BID ADDENDUM 2

Project: GREEN CHIMNEYS
**HVAC UPGRADE AT POOL/GYM BLDG - RE-BID
PROJECT #50-19-01**

Engineer: Eisenbach & Ruhnke Engineering, P.C.
291 Genesee Street
Utica, NY 13501
E&R Project #: 05-19-01

M102A

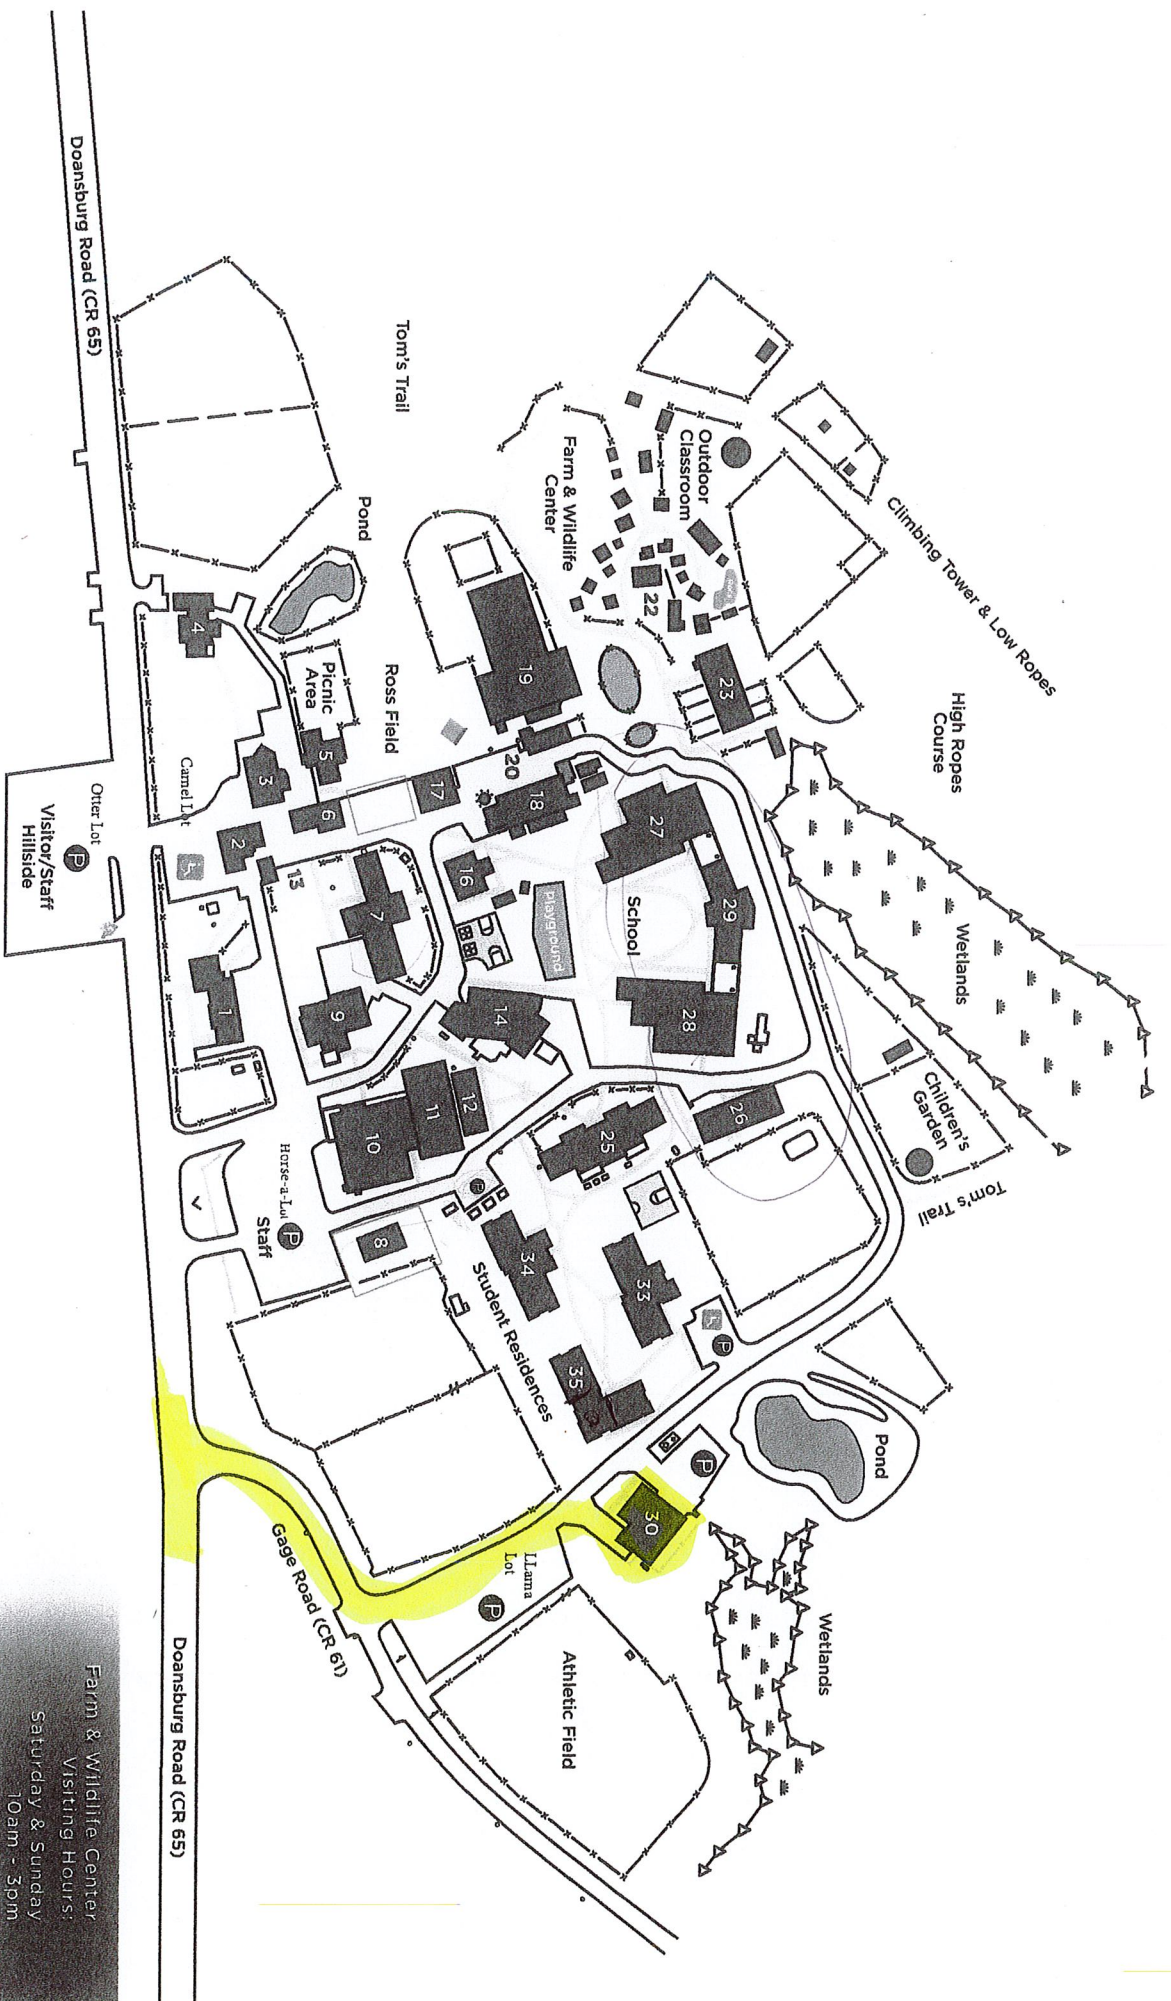
ITEM #1 – SKETCH M102A

- Add the Attached Sketch M102A to the Contract Documents.

There is a magnified detail showing a 36" high roof railing but it does not indicated the extent
of the length of the railing. Where exactly does this railing need to be installed, what is the length,
& how long can the railing be before an additional support needs to be bolted to the roof?

- NOTES:
1. PROVIDE ALUMINUM RAILINGS..
 2. TO BE CONSTRUCTED IN COMPLIANCE WITH NYS BUILDING CODES AND NYS SED MANUAL PLANNING STANDARDS.
 3. DISTANCE BETWEEN BOTTOM OF BOTTOM RAILING AND ROOF NOT TO EXCEED 4".
 4. PROVIDE GALVANIZED ANCHORS TO ROOF AS REQUIRED.

the handrail is approx 30'-0" east to west direction
and approx. 19'-6" north to south direction and the
supports are 5'-0" center to center and needs to be installed
just inside the parapet
